## CITY OF ALBUQUERQUE

March 3, 2023

RE: Ray's Flooring – Phase 1 8920 Pan American Freeway NE Conceptual Grading & Drainage Plans Engineer's Stamp Date: 02/21/23 Hydrology File: J10D027

OVERALL CONCEPTUAL GRADING PLAN

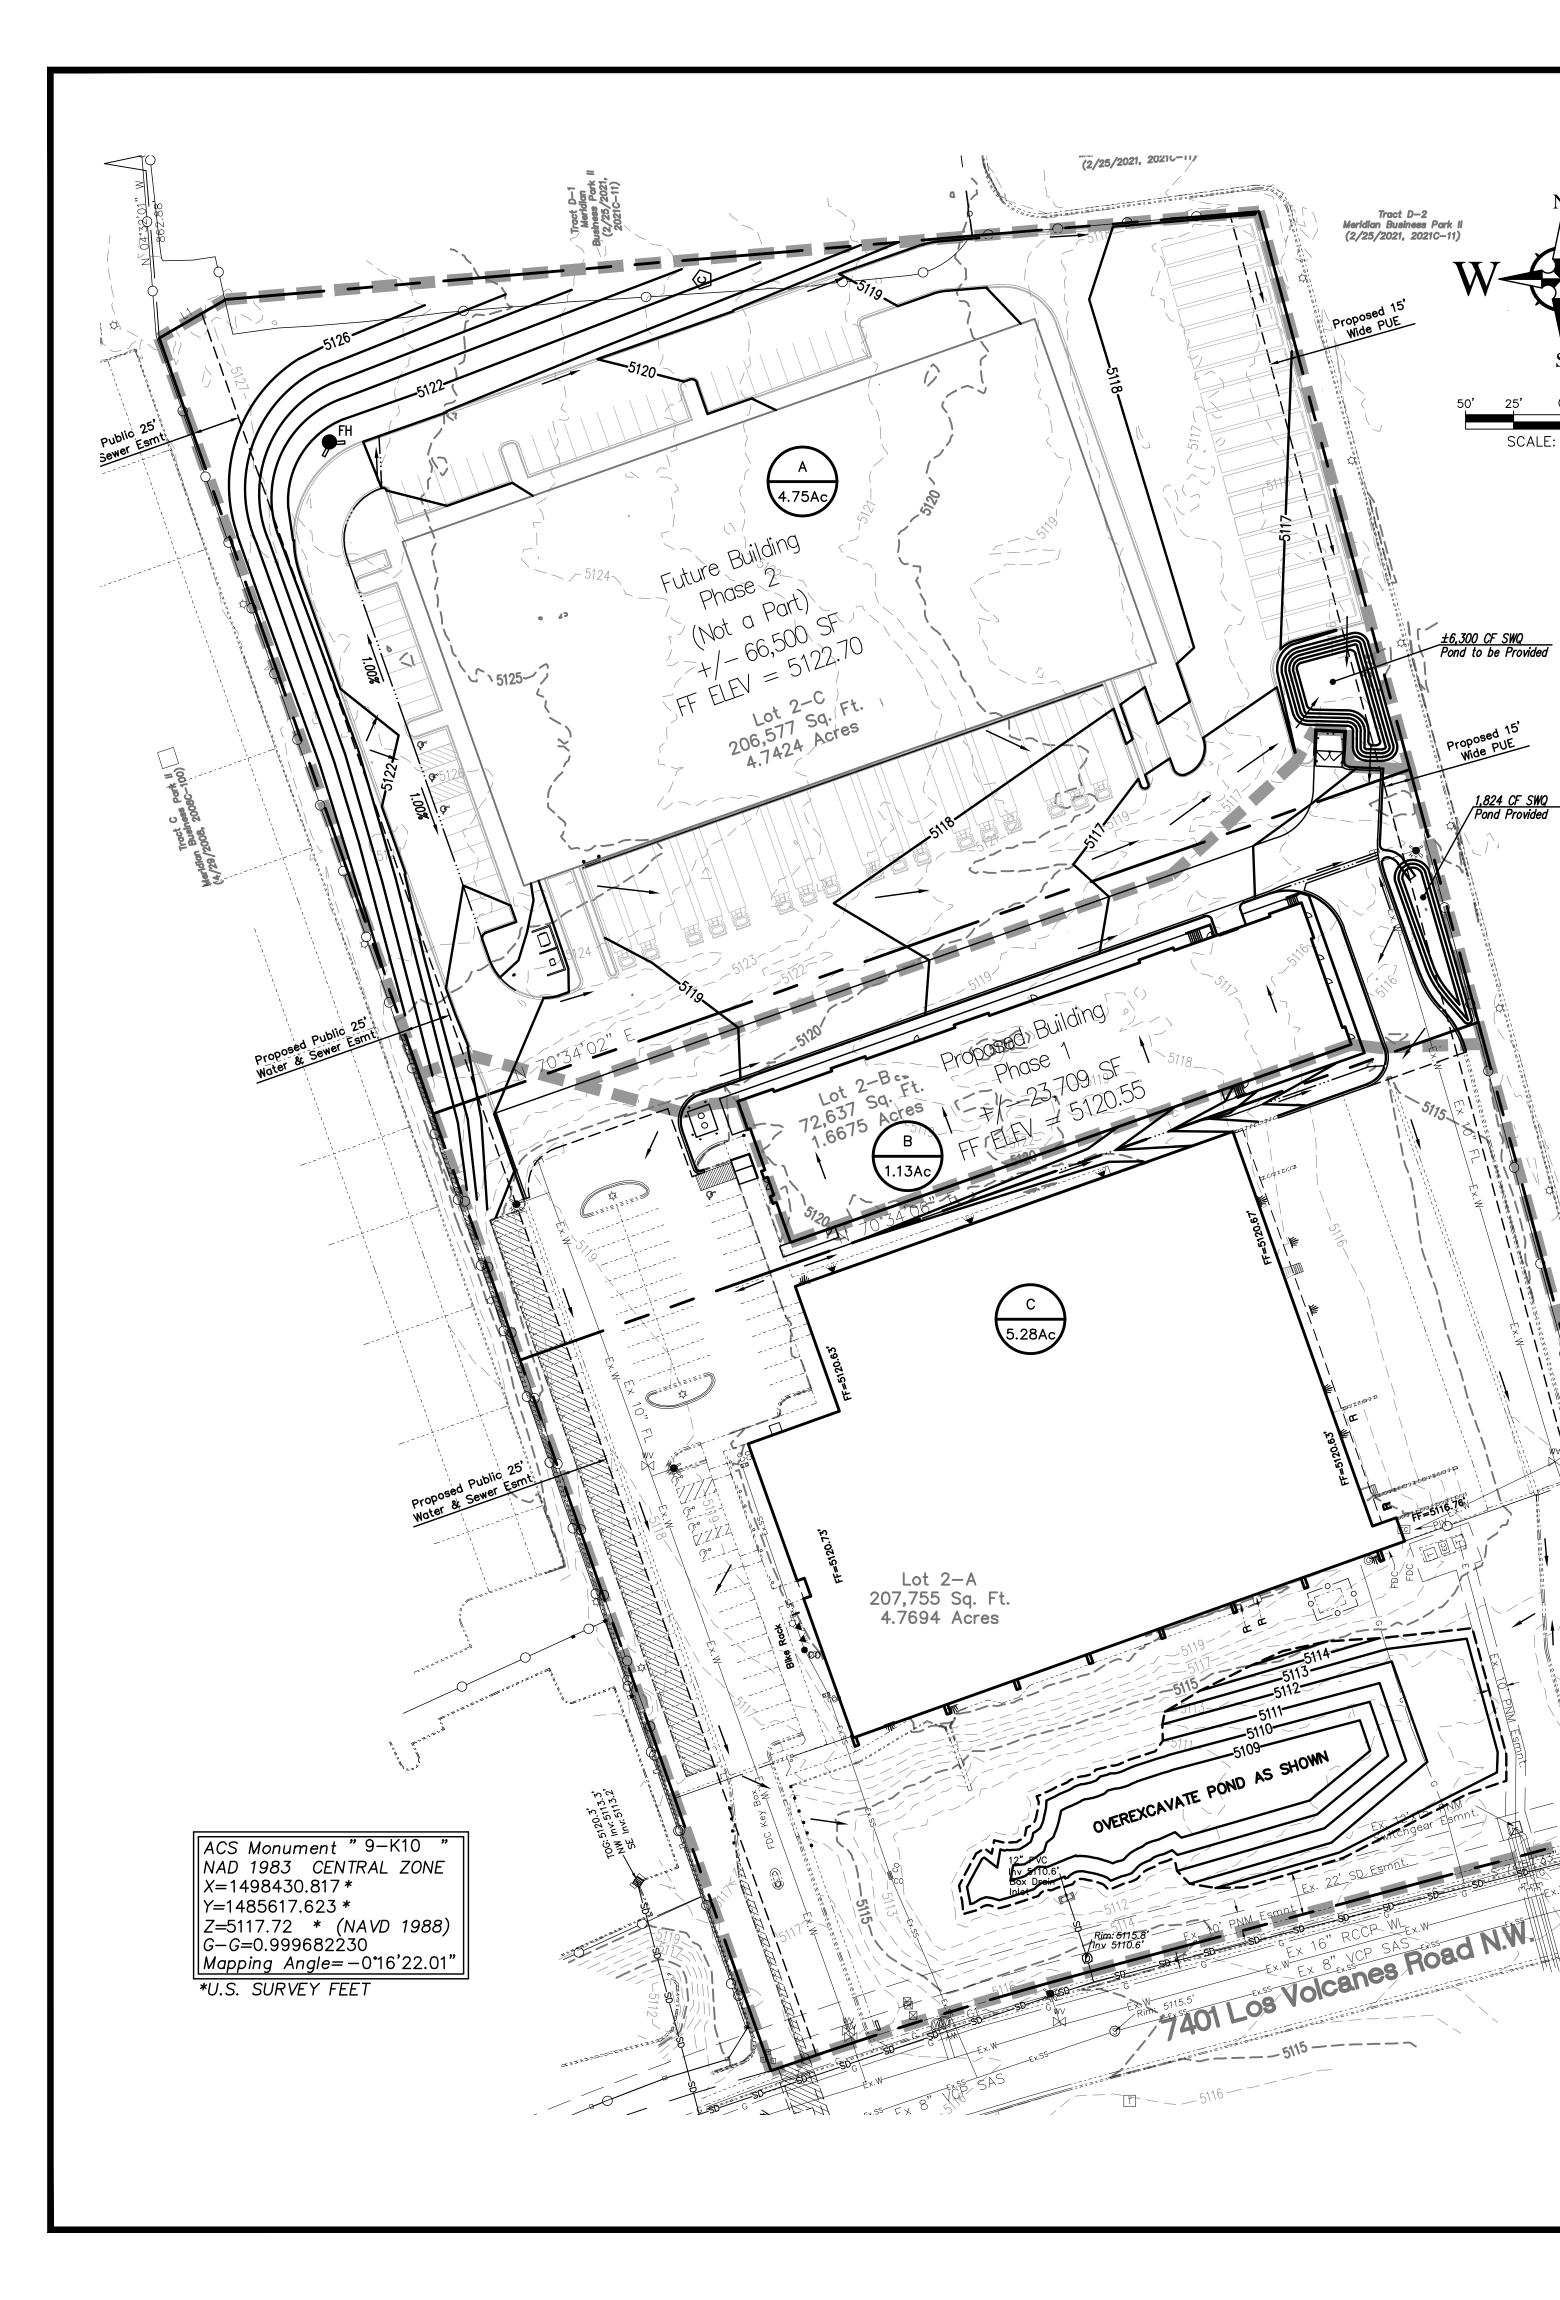
Please submit a more detailed Grading & Drainage Plan to Hydrology for review and approval. Please note that existing detention pond outfall structure will have to be relocated and/or replaced to the bottom of the new proposed deepened detention pond. This digital (.pdf) is emailed to <u>PLNDRS@cabq.gov</u> along with the Drainage Transportation Information Sheet.
